BURLINGTON DEVELOPMENT REVIEW BOARD

Tuesday August 21st, 2018, 5:00 PM

PUBLIC HEARING NOTICE

TO: Development Review Board
FROM: Scott Gustin
DATE: August 21, 2018
RE: 18-1190CU; 233 Pearl Street

PROPOSED GARAGE 12'x20'

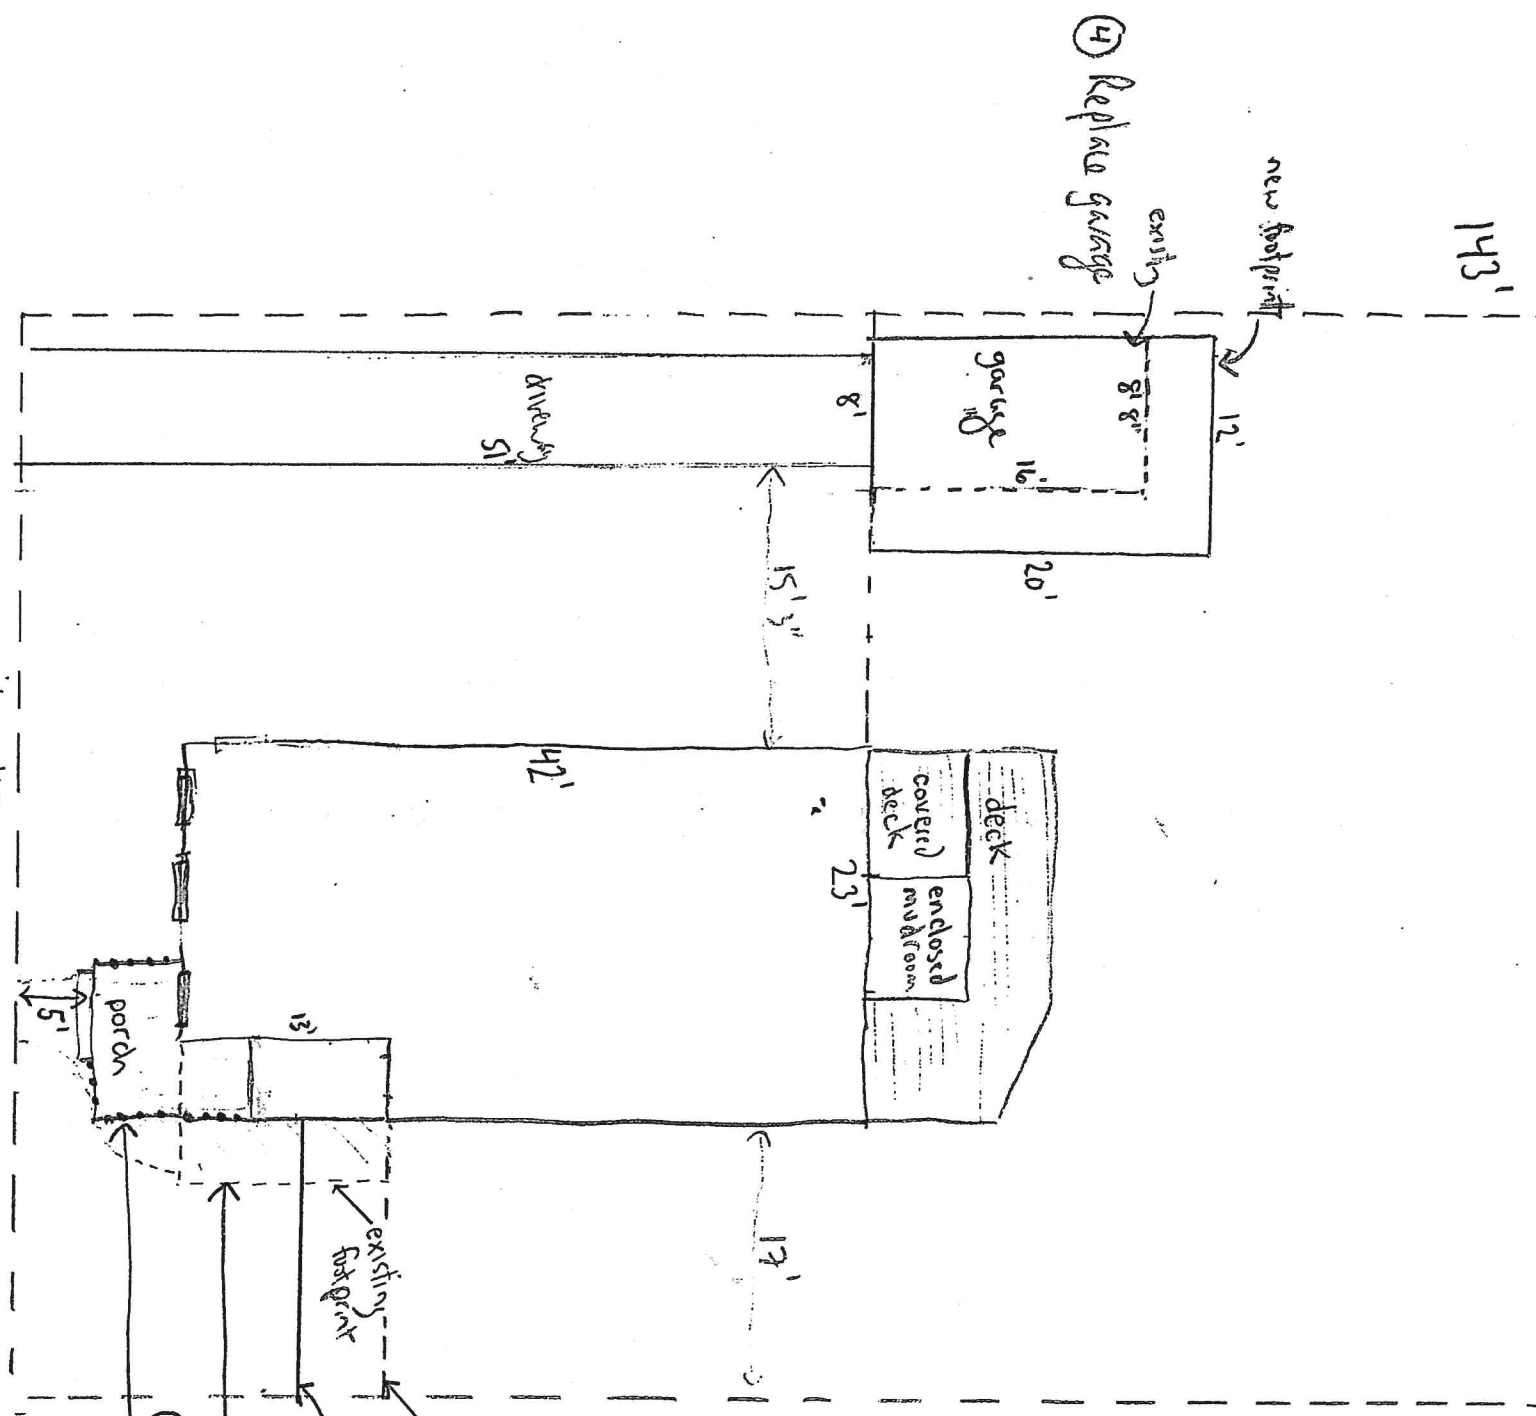
Demolition of the detached garage will not impact the historic home. The proposed garage will be of a similar, somewhat larger size in the same location behind the home. Configuration as a single-bay detached garage will remain. Photo documentation prior to demolition would provide a minimal amount of mitigation. **(Affirmative finding as conditioned)**

SITE PLAN

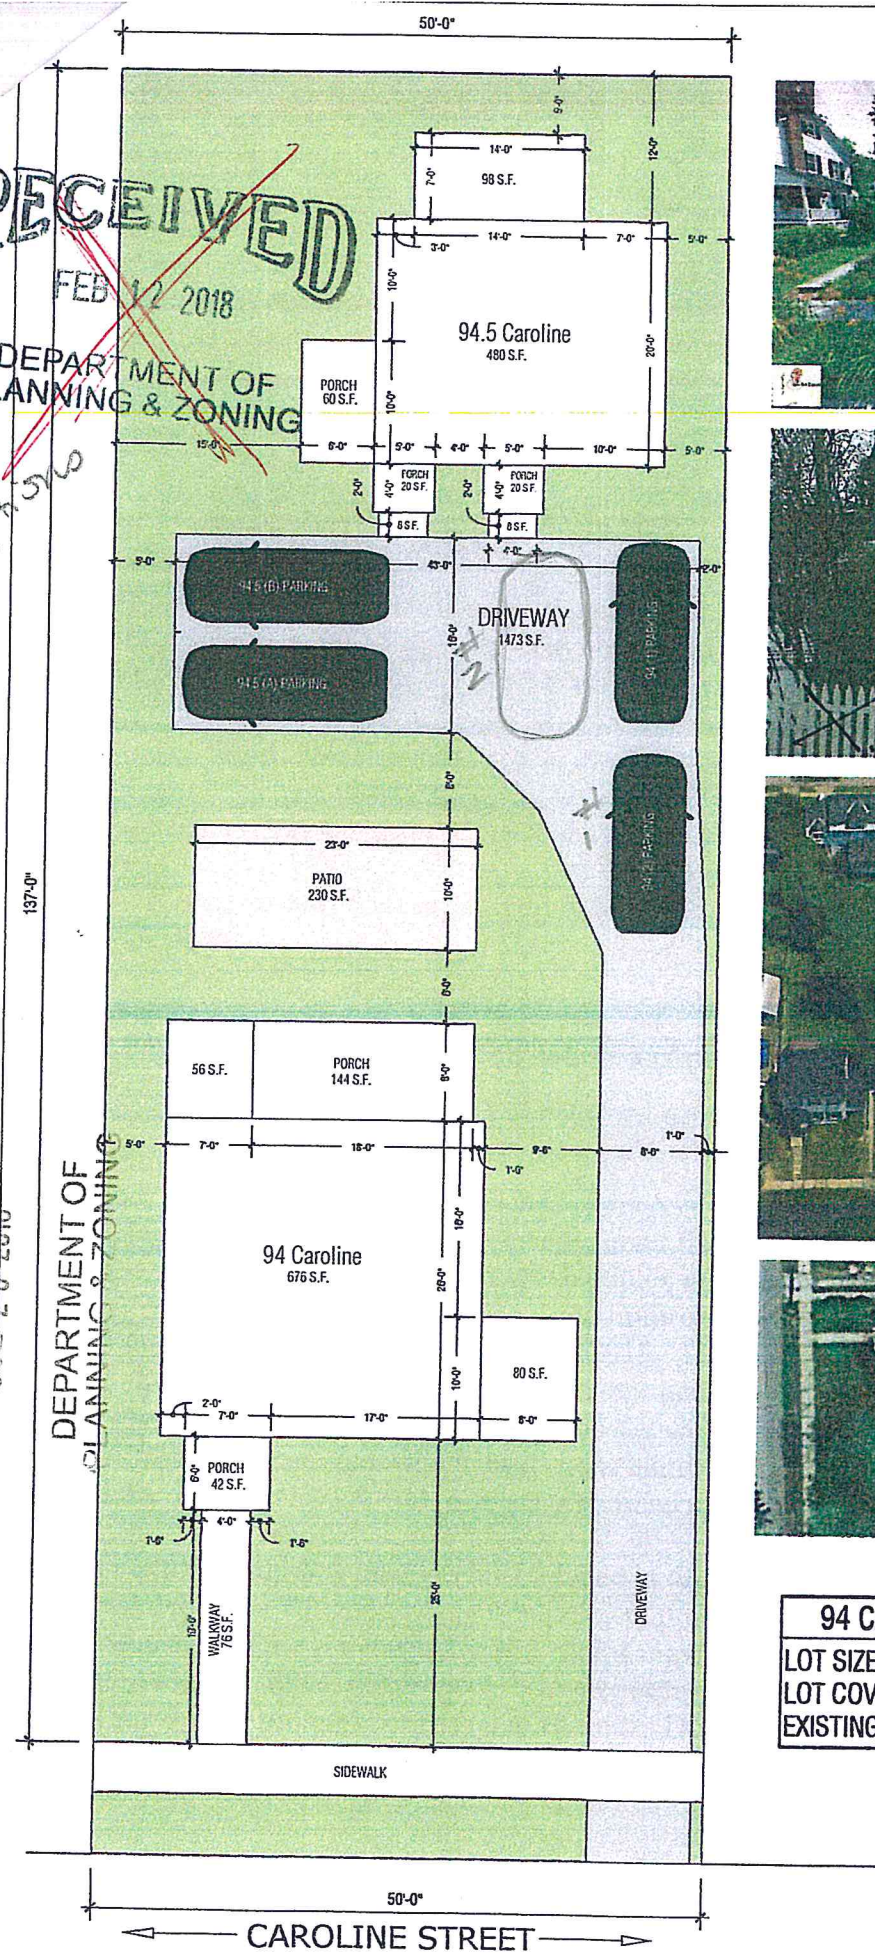
The parking arrangement depicted in the site plan includes 5 parking spaces in stacked configuration at differing angles. Alluding to Sec. 8.1.14, *Stacked and Tandem Parking Restrictions*, the application notes that an attendant will be available to move vehicles if necessary. No further details are provided. No changes to the configuration have been made since the prior application denial – only this assertion that an attendant will be present.

The driveway in the present application could be modified to enable a tandem parking arrangement or even an arrangement wherein no vehicles need to be moved to enable access to/from the bed and breakfast spaces. The applicant has chosen not to make any changes. All of the vehicles will be stacked at the bottom. The assertion that an attendant will be present is vague and does not indicate who it will be (i.e. the owner, neighbor, etc.). The applicant has had since April 2018 to provide a workable, acceptable parking arrangement. The proposed parking arrangement; however, remains unacceptable. **(Adverse finding)**

I've looked over your new zoning permit application for short term rental/B&B at 94 Caroline Street. The application is presently incomplete. I see only the application form. There is no explanation of how parking will be provided and managed, nor is there a site plan. As we discussed, you need to provide at least a narrative as to how the parking will be managed. As I recall, you had said you'd like to go with stacked parking with an onsite parking manager. Please send along a narrative for the Development Review Board's consideration as to how you plan to manage parking. As to the site plan, you may use the prior site plan as a template; however, it needs to be updated to depict two pairs of tandem spaces. Right now, it does not.

The three residential units required a total of 6 parking spaces (2 per unit). The “L” shaped driveway is sufficient to contain 4 parking spaces (2 pairs of 2 tandem spaces). Tandem spaces are allowed for single family homes and duplexes. Note that the parking layout depicted on the site plan is not acceptable – revision to tandem layout is required for the present uses.

1 VR4 - Overhead Vehicular Regulatory
scale: 1/4"=1'-0"

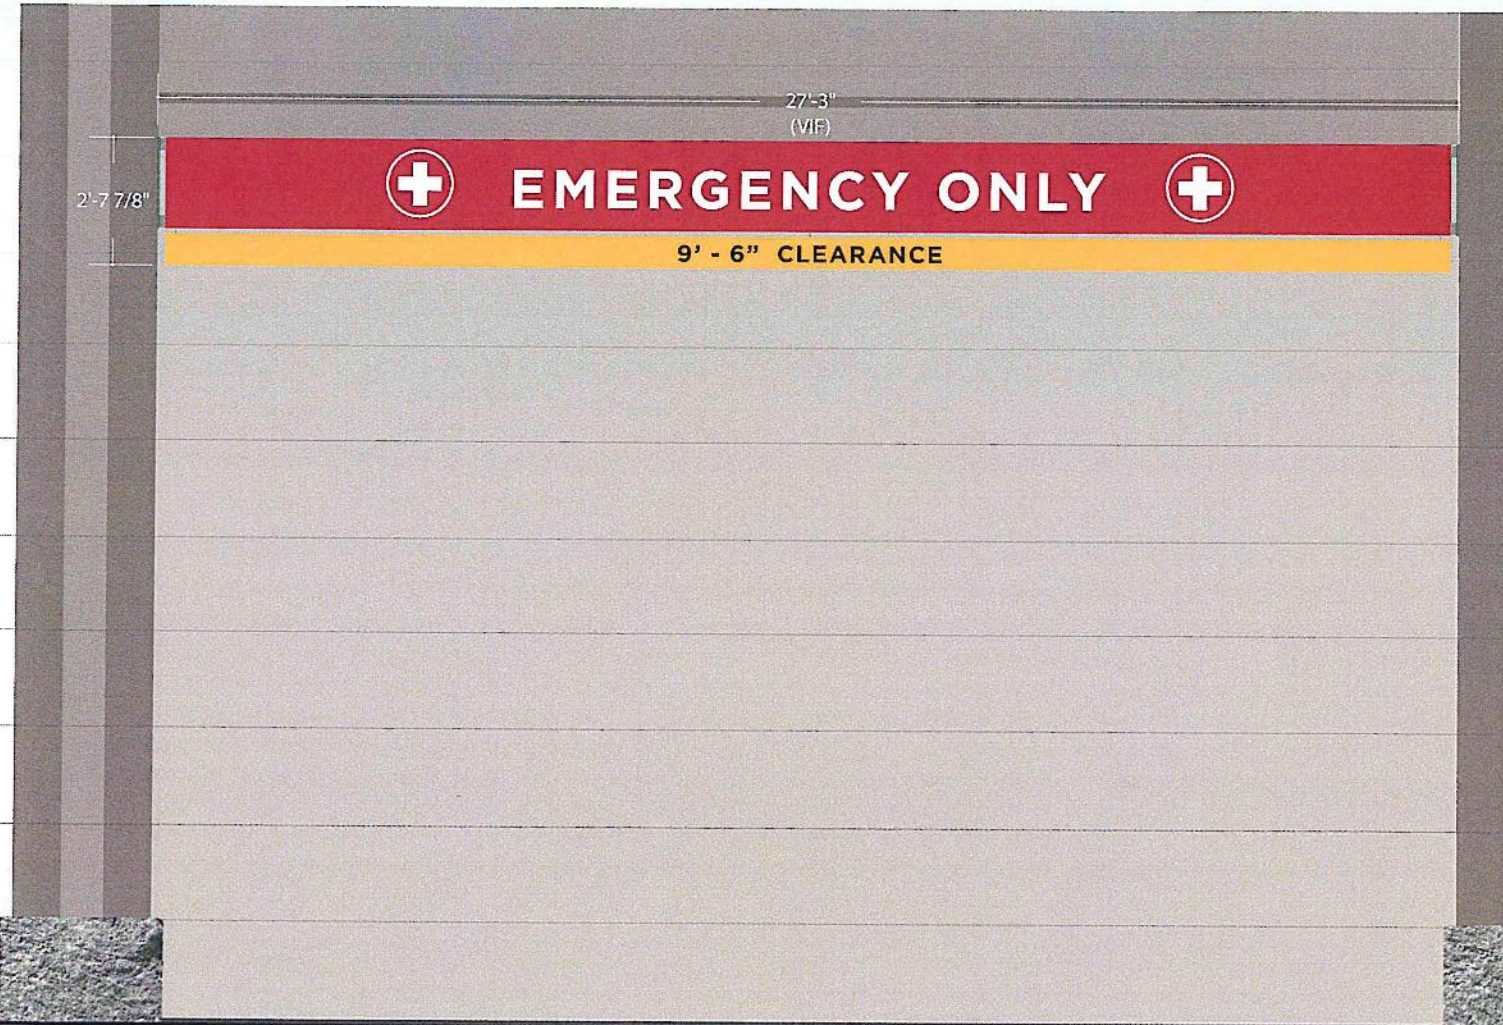
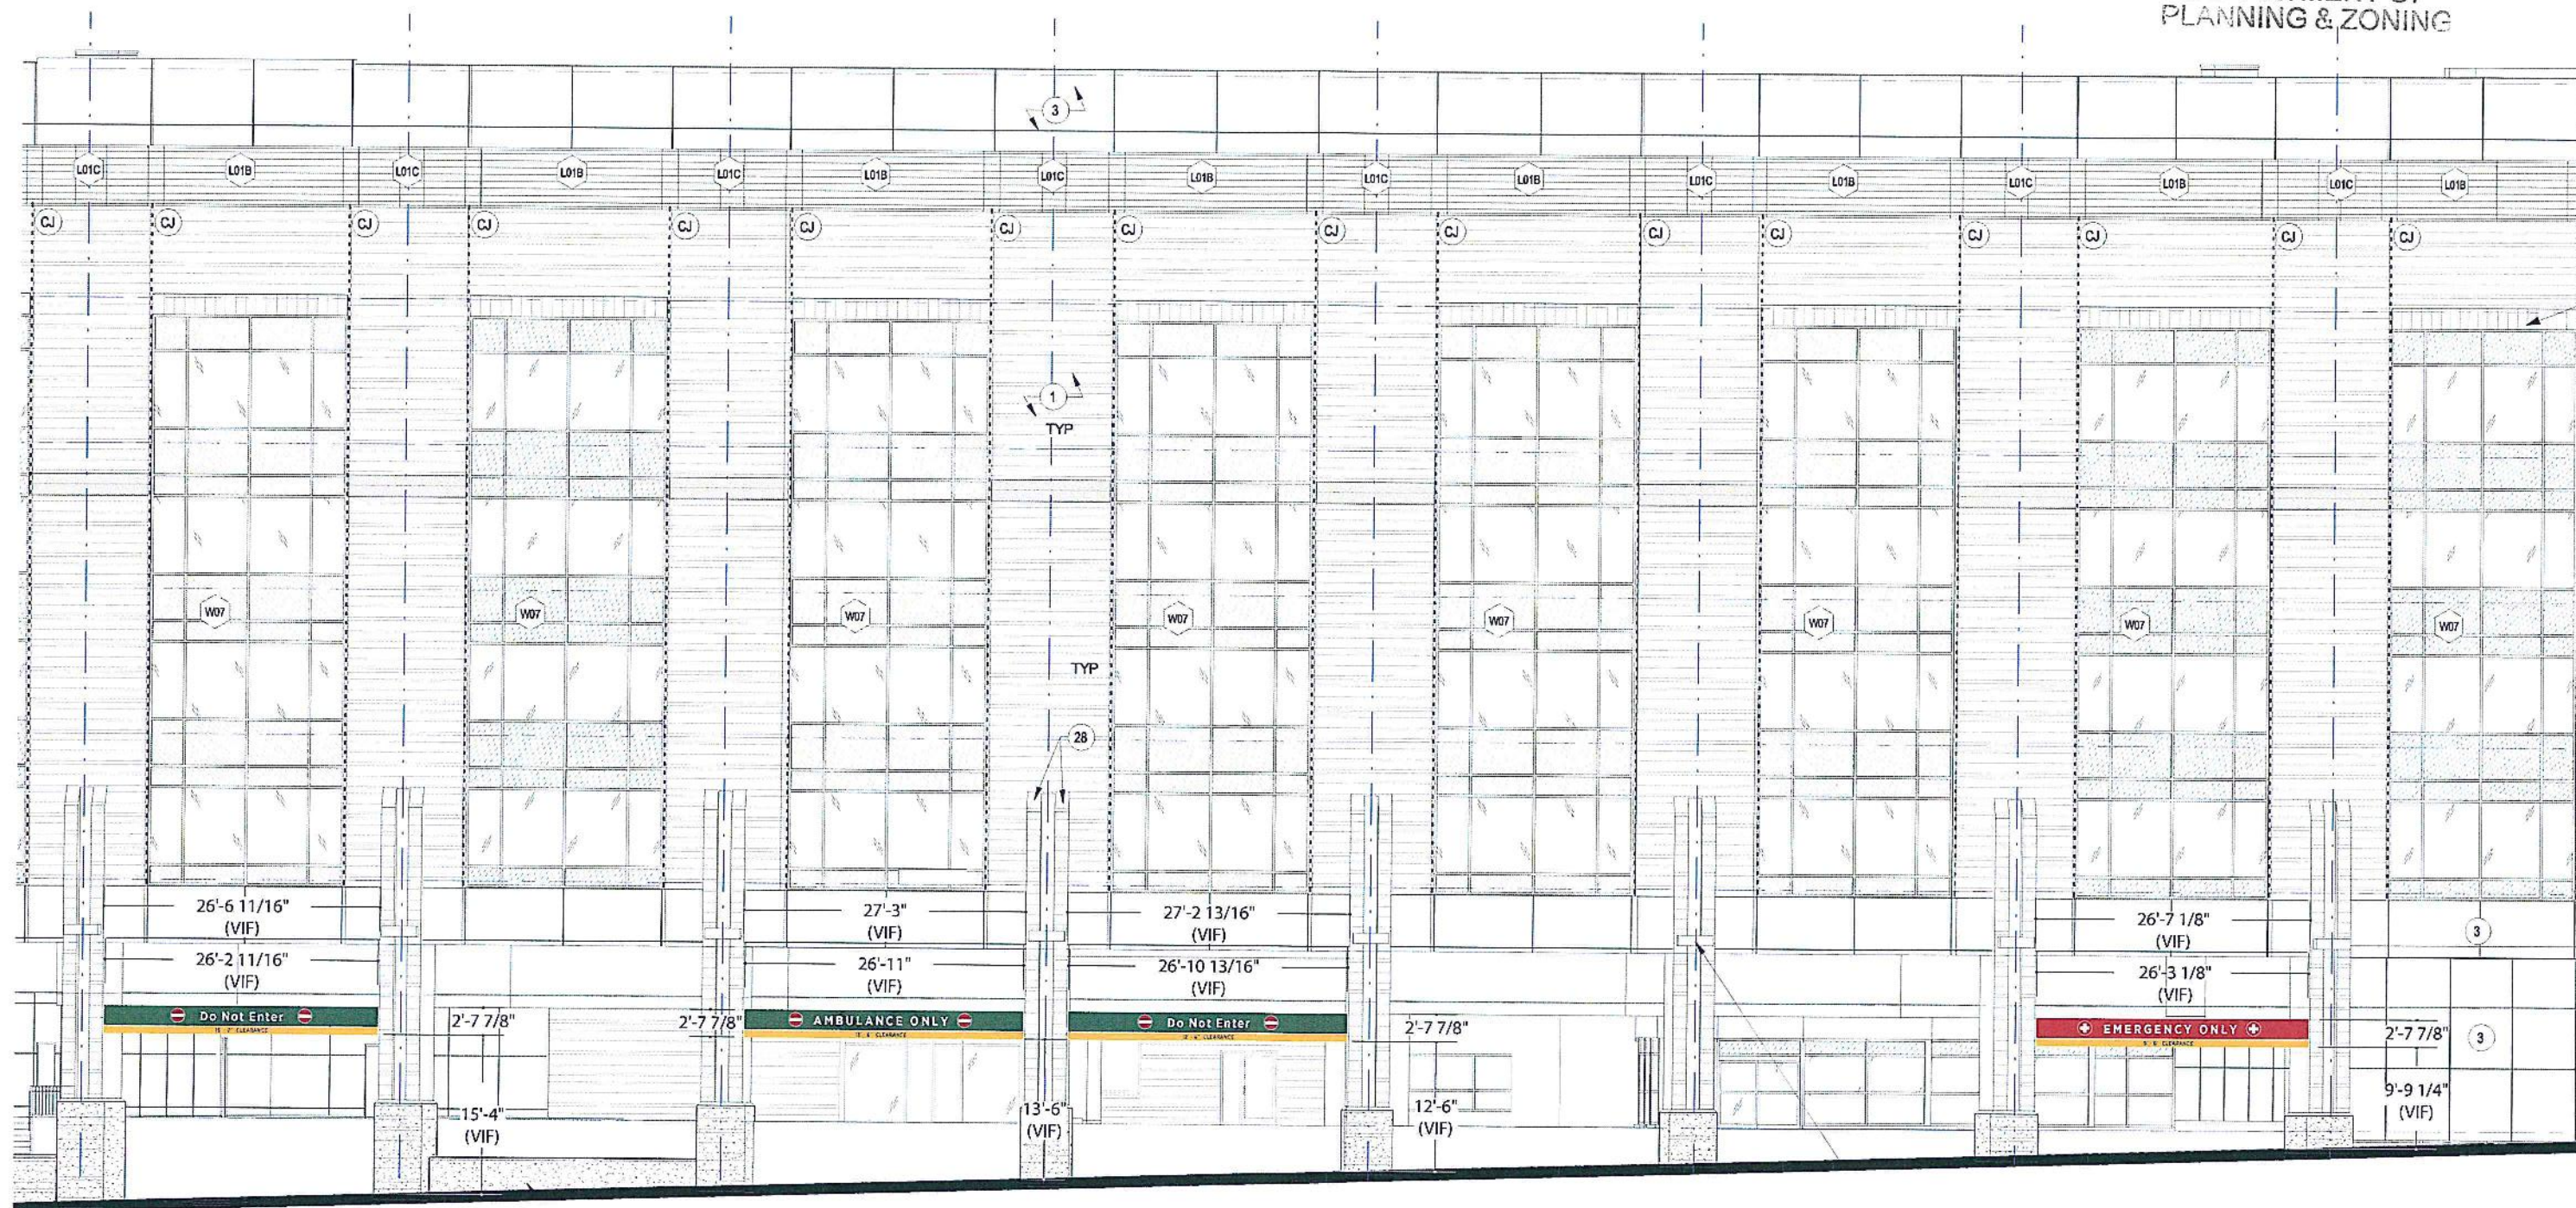
The 4 new hanging parallel signs are each ~ 70 sf in size and add up to more than 200 sf together. Three of them (the VR4 signs) also exceed 14’ in height where mounted to the building. This criterion enables some flexibility from the existing sign standards relative to size. Rather than limit the collective area to 200 sf, this criterion states that no individual sign may exceed the size limitations of Sec. 7.2.3 (a) (3). In this case, total sign area exceeds 200 sf; however, all 4 of the signs comply with the 1 sf per 1 linear foot of building frontage standard, and each individual sign is well below 200 sf. Sign mounting height of more than 14’ is enabled by footnote 2 in Table 7.2.1-1. The footnote states that signs above 14’ high are permissible so long as they are not internally illuminated and do not exceed the ceiling height of the first floor. Such is the case here.
